**SEWER BASIS OF DESIGN REPORT  
FOR**

**WINERY RESIDENCES OF SCOTTSDALE  
SWC GOLDWATER BOULEVARD & 1<sup>ST</sup> STREET  
SCOTTSDALE, ARIZONA**

**PRELIMINARY Basis of Design  
Report**

- ACCEPTED  
 ACCEPTED AS NOTED  
 REVISE AND RESUBMIT

**PRELIMINARY UTILITY PLAN**  
**Bowman**  
CONSULTING

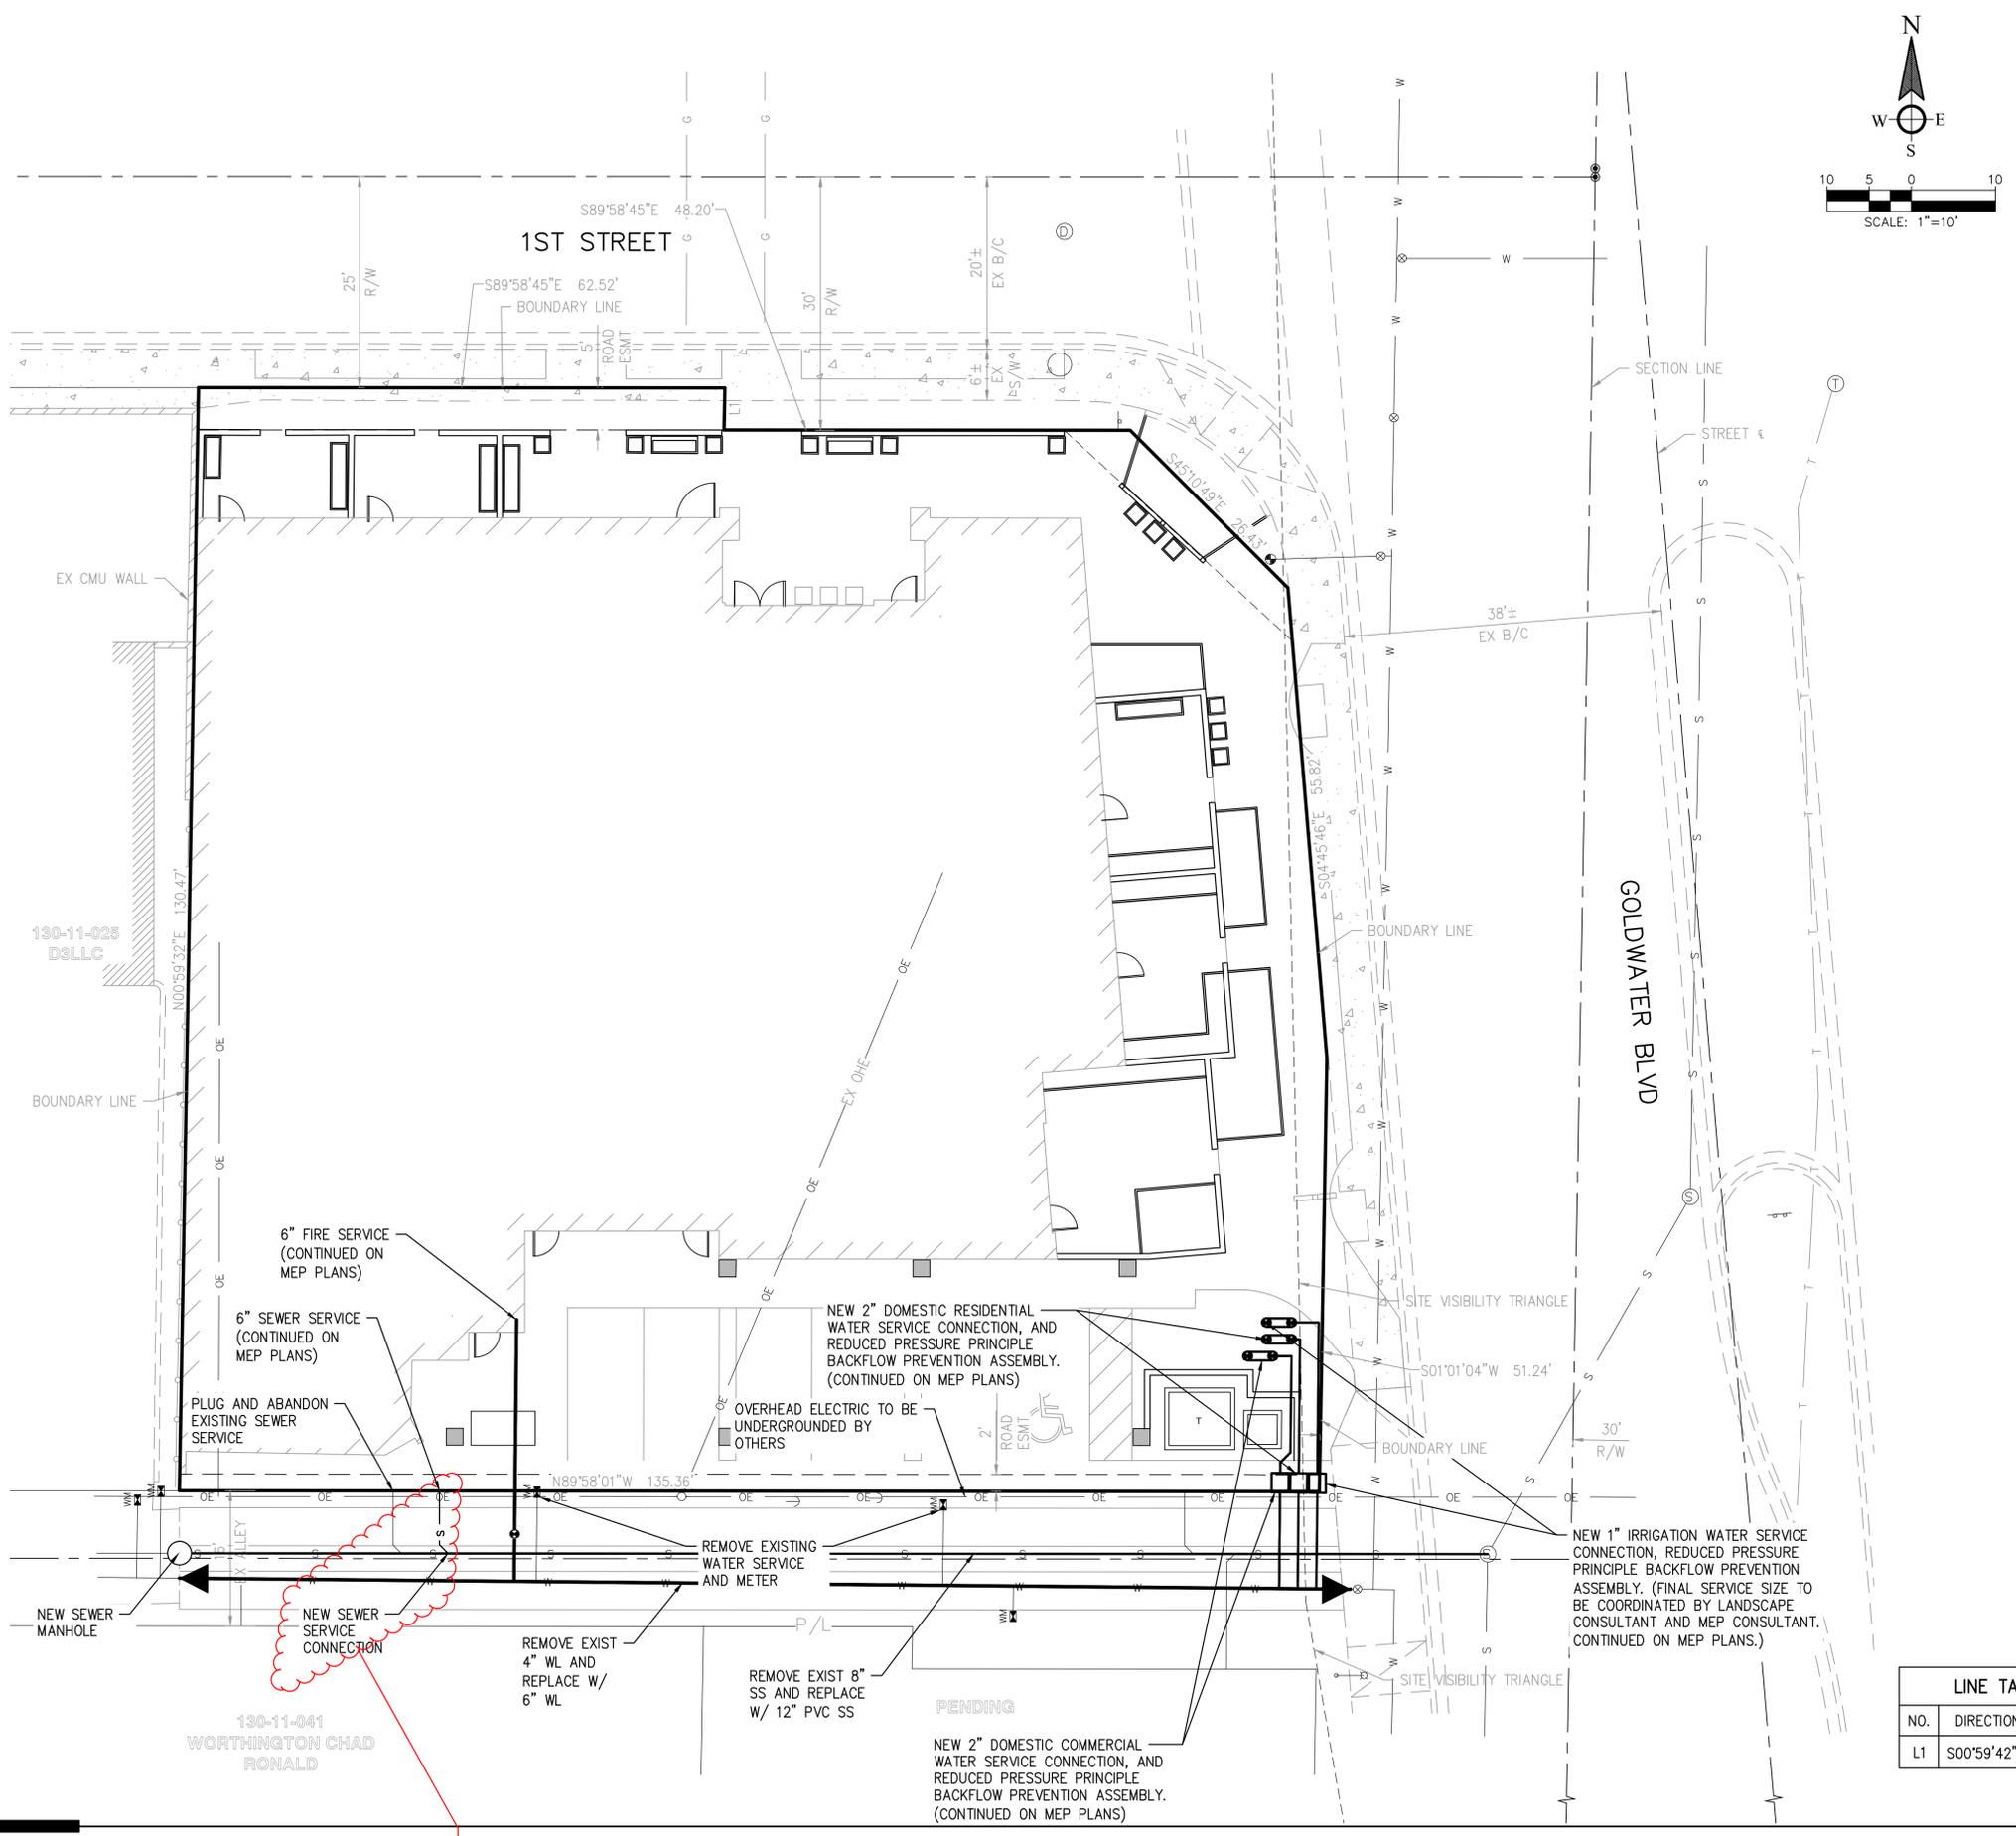
- 1) The new proposed 12-inch alley sewer line will need to be placed at least 9ft centerline to centerline from the existing 4-inch alley water line to obtain minimum horizontal clearance DS&PM 6-1.402, section 7.c.
- 2) Minimum slope of new 12" sewer 0.3% (2.5fps @ d/D=1), greater acceptable up to 10fps. DS&PM 7-1.404
- 3) New sewer must maintain 6ft horizontal clearance from all dry utilities, structures, and edge of ROW. COS detail 2401
- 4) If applicable the bench of the receiving manhole in Goldwater must be reformed to accept 12" line flow.
